Access Compliance Report Public Rights-of-Way (Curb Ramps)

Main Street: DORSETSHIRE_LN Cross Street: BIMINI_DR Location: NE

ADA ID: RPRK211013130738 Ramp Type: Type 1 - Perpendicular Diagonal Initial Pass/Fail: Fail Overall Compliance: No Severity Score: 2

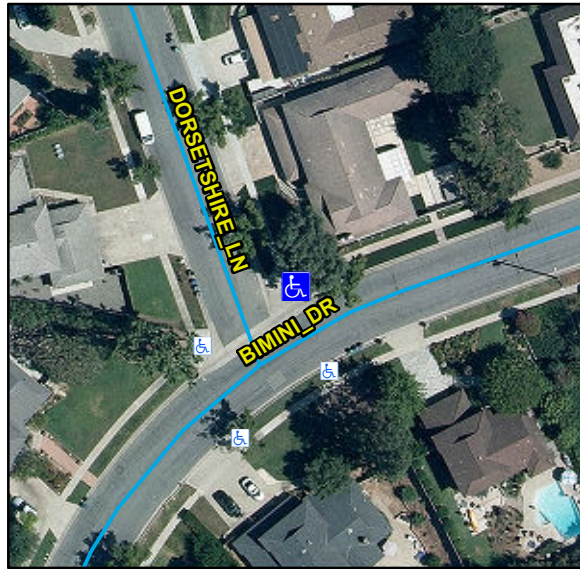
Compliance	Description	Data	Compliance	Description	Data
N/A	Ramp Length (in)	124	N/A	Flare Type LT	
Yes	Ramp Width (in)	48			N/A
Yes	Ramp Run Slope (%)	3.9	N/A	Flare Slope LT (%)	N/A
No	Ramp Cross Slope (%)	3.1	N/A	Flare Traversable LT	N/A
N/A	Landing Present	N/A	N/A	Flare Type RT	
N/A	Landing Length (in)	N/A			N/A
N/A	Landing Width (in)	N/A	N/A	Flare Slope RT (%)	N/A
N/A	Landing Run Slope (%)	N/A	N/A	Flare Traversable RT	N/A
N/A	Landing Cross Slope (%)	N/A	N/A	DWS Provided	N/A
N/A	Landing Movement Obstructed?	N/A	N/A	DWS Contrast	N/A
	Landing Movement Type	N/A	N/A	DWS Length (in)	N/A
N/A	Landing Shared	N/A	N/A	DWS Full Width	N/A
N/A	Clear Space	Yes	N/A	DWS Offset Left (in)	N/A
N/A	Clear Space To Crosswalk (in)	N/A	N/A	DWS Offset Right (in)	N/A
N/A	Marked Crosswalk 1	No	N/A	Marked Crosswalk 2	No
	Crossing 1 Direction	W		Crossing 2 Direction	S
	Marked Crosswalk 1 Width (in)	N/A		Marked Crosswalk 2 Width (in)	N/A

Remove & Replace Curb Ramp With Two New Directional Ramps or Equivalent.
